MEMORANDUM

To: East Lyme Inland Wetlands Commission
From: Gary A. Goeschel II, Director of Planning/ Inland Wetlands Agent 
Date: January 13, 2025
Re: Cedarbrook Lane & Catbird Lane Resubdivision, Heritage Phase 3; Kristen Clarke, P.E., Applicant; Hathaway Farm LLC, Owner; Application for a Resubdivision of approximately 4.1 acres, and Waiver Request from Section 4-2-3(I) Stormwater Management Plan, of land located at Cedarbrook Lane & Catbird Lane, Tax Assessor's Map #36, Lot #31, East Lyme, CT, Zoned RU-40

Upon review of the above referenced application and the proposed 4-Sheet plan set entitled "Heritage At East Lyme Subdivision, Re-Subdivision of Assessors Map 36.0 Lot 31, Property of Hathaway Farm, LLC, Cedarbrook Lane, East Lyme, CT, Dated September 1, 2025," prepared by John Paul Mereen, L.S. of Gerwick – Mereen, LLC and Sheet 4 of 4 entitled "Conceptual Site Plan, Assessors Map 36.0, Lot 31, Cedar Brook Ln., East Lyme, CT, Scale 1" = 40', dated July 29, 2025, Rev. 11/23/25" prepared by Timothy A. May, P.E. of May Engineering, LLC, I offer the following comments and Findings:

FIGURE 1

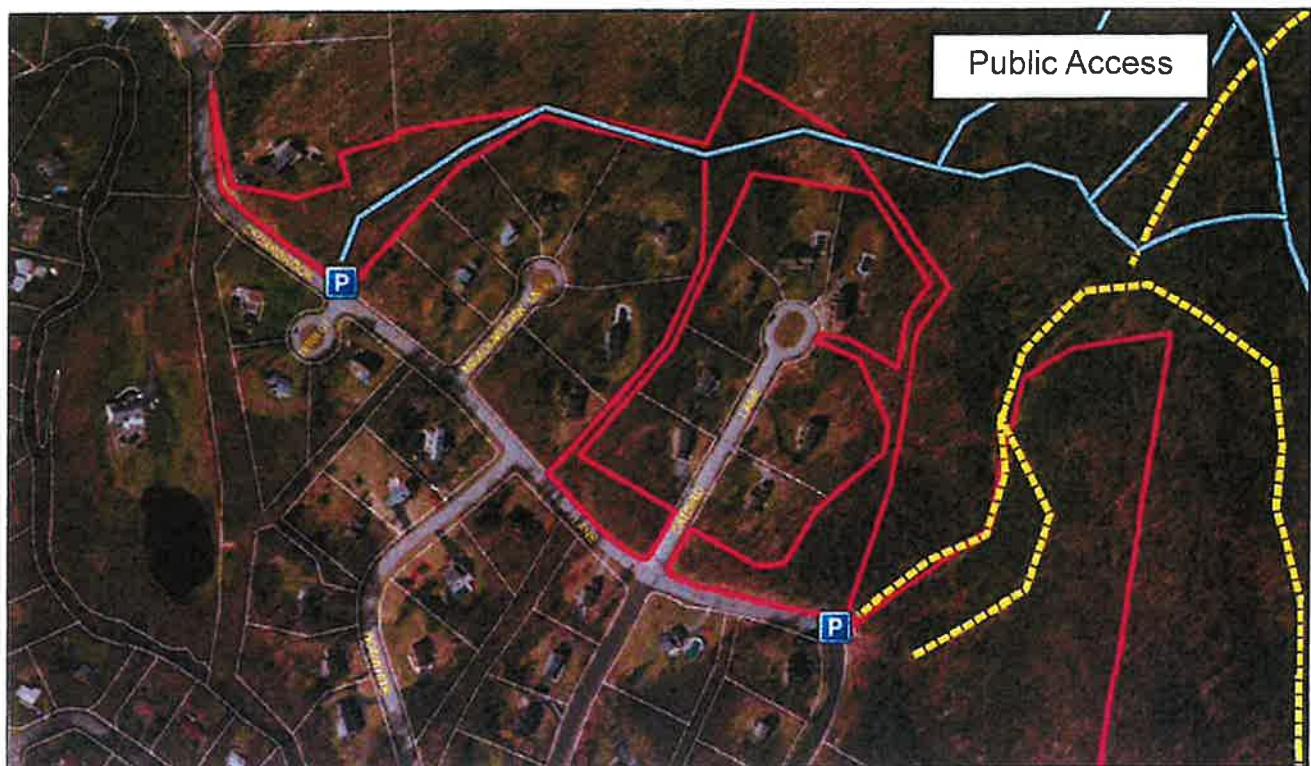
3. On or about July 2012, the East Lyme Planning Department developed several maps for KSK Associates, LLC in support of their application to the Connecticut Department of Energy and Environmental Protection (DEEP) for an Open Space and Watershed Land Acquisition Grant. It was my understanding the grant application proposed two parking areas, one 36' x 55' parking area located in the southeast corner of the subject property for public access to the 200 +/- acres of open space currently owned by the New England Forestry Foundation a (Exhibit 1 attached). As the Grant was awarded and the property

transferred, is there still any obligation for New England Forestry to install this parking area as well as the other proposed 26' x 50' parking area?
